CALIFORNIA COASTAL COMMISSION

**STAFF REPORT: APPEAL
SUBSTANTIAL ISSUE DETERMINATION
AND DE NOVO REVIEW**

Appeal Number..... A-3-SLO-00-121
Local Government..... San Luis Obispo County
Decision Approved with Conditions
Applicant Tom & Karen Hogan
Appellants Ruel J. Czach
Project Location 36 North Ocean Avenue (Estero Planning Area), Cayucos, San Luis Obispo County (APN 064-114-008)
Project Description..... Allow continued use of approximately 6,400 square feet of outdoor building material storage area in association with an existing hardware store; replacement of fence and installation of retaining wall.
File Documents San Luis Obispo County certified Local Coastal Program; Local Administrative Record for Coastal Development Permit D990094D; *Riparian Vegetation of Little Cayucos Creek Next to Ocean Avenue Hardware* (V.L. Holland, Ph.D., June 9, 2000).

EXHIBIT
Revised Site Plan

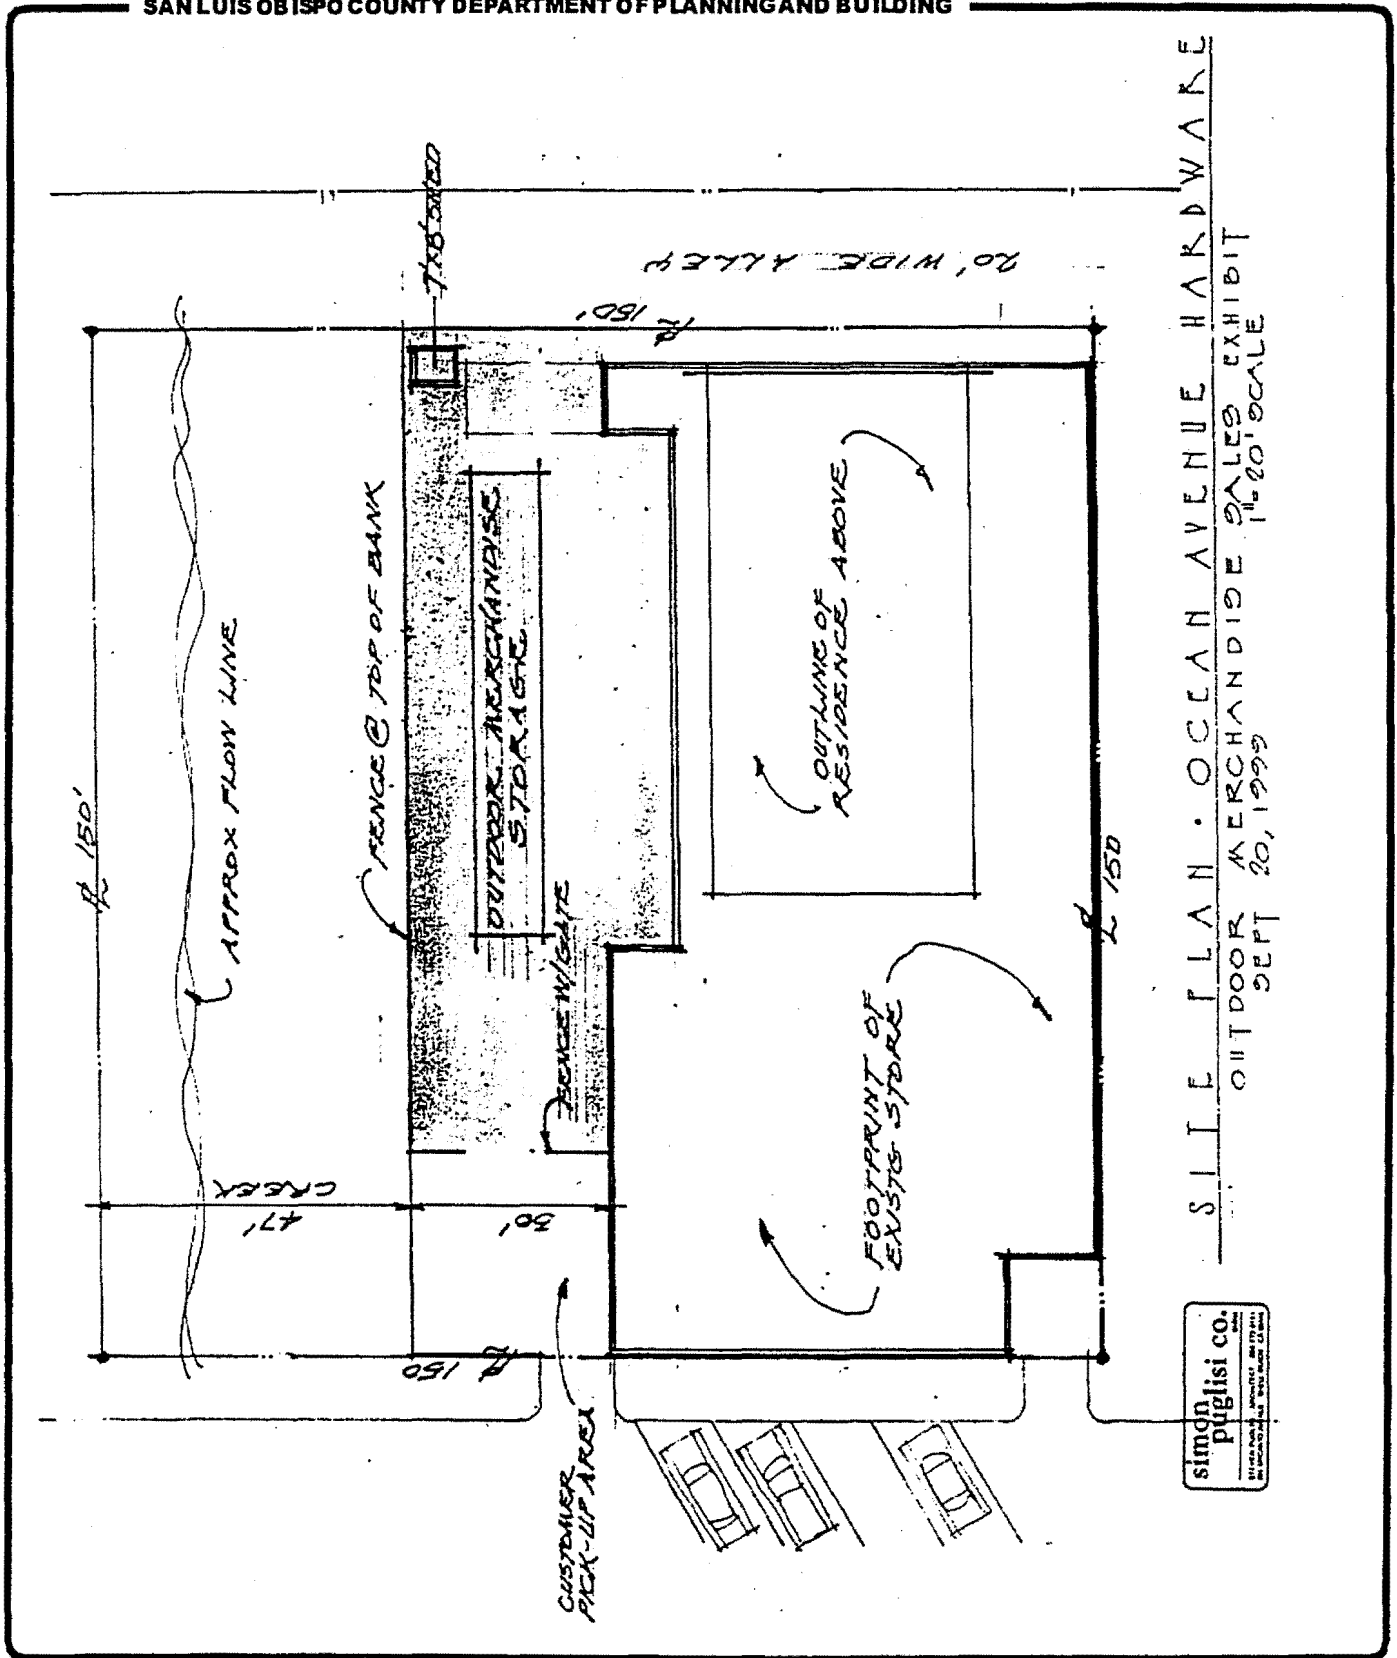
According to the appellant, an existing wooden fence located at the edge of the outdoor storage area was removed, a 10 to 15-foot swath of riparian vegetation along the creek was removed, and a retaining wall and chain link fence were installed to replace the existing wooden fence (see photos in Exhibit 3). In response to the appellant's contentions during the local appeal process, the applicant had a Plant and Restoration Ecologist (V.L. Holland, Ph.D) perform a biological assessment of the riparian area. The botanical report, attached as Exhibit 5, examined the riparian vegetation along this particular section of Little Cayucos Creek and evaluated the impacts of the new fence on the riparian vegetation and the creek. According to this report, there is no evidence that the riparian vegetation had been significantly altered during the installation of the new fence and no indication that a swath of 10 to 15 feet of riparian vegetation had been removed. Holland further indicates that no willow trees were removed with the installation of the new fence; however, the landowners did prune willow branches that had grown over the fence and driveway.

The biologist states that the new fence and retaining wall are in the same location as the old fence except for a small section near Ocean Avenue, where it ranges from one to four feet closer to the riparian vegetation. The report indicates that there are no signs that riparian vegetation was removed during the fence replacement, the new fence protects the riparian zone, the retaining wall helps stabilize the slope and prevents erosion along the fence line, and the existing setback is adequate as long as proper precautions are taken to prevent contaminants such as petroleum products, herbicides, and pesticides from entering the creek. Additionally, the County staff indicated that the United States Fish and Wildlife Service (USFWS), Department of Fish and Game (DFG), and Army Corps of Engineers were contacted, and all indicated that no permit was needed from their agencies, as the project did not affect the creek.

However, the project appears to be inconsistent with CZLUO Sections 23.04.180, 23.07.164, 23.07.170, and 23.07.174a because although no riparian vegetation was removed or damaged during the installation of the fence, the continued use of the outdoor storage area, without adequate Best Management Practices, may adversely impact the creek environment. Secondly, the project is inconsistent with CZLUO Sections 23.07.172 and 23.07.174d because the outdoor storage area and new fence are located closer than 10 feet from the stream bank and are not permitted uses within a riparian setback area. Finally, the project appears to be inconsistent with Policies 1, 5, 16, and 18, 19, and 21 (implemented as CZLUO Section 23.07.174) for ESH regarding the protection of coastal streams because adequate Best Management Practices were not incorporated into the County's approval. **Thus, a substantial issue is raised by these contentions of appeal.**

2. **Revised Plans.** PRIOR TO ISSUANCE OF THE COASTAL DEVELOPMENT PERMIT, the permittee shall submit for review and approval by the Executive Director, the following:

- a) A revised floor plan indicating the location of the existing offices and retail space;
 - b) A parking plan, consistent with CZLUO Section 23.04.168 (Parking Lot Construction Standards) indicating the placement of six off-street parking spaces on APN 064-114-008. Necessary landscape elements required by CZLUO Section 23.04.168 shall also be noted on the plan, indicating the location, species (all plant material shall be native species), container size, spacing and number of trees, shrubs, groundcover of proposed plant materials, and a calculation of the total area proposed for planting.
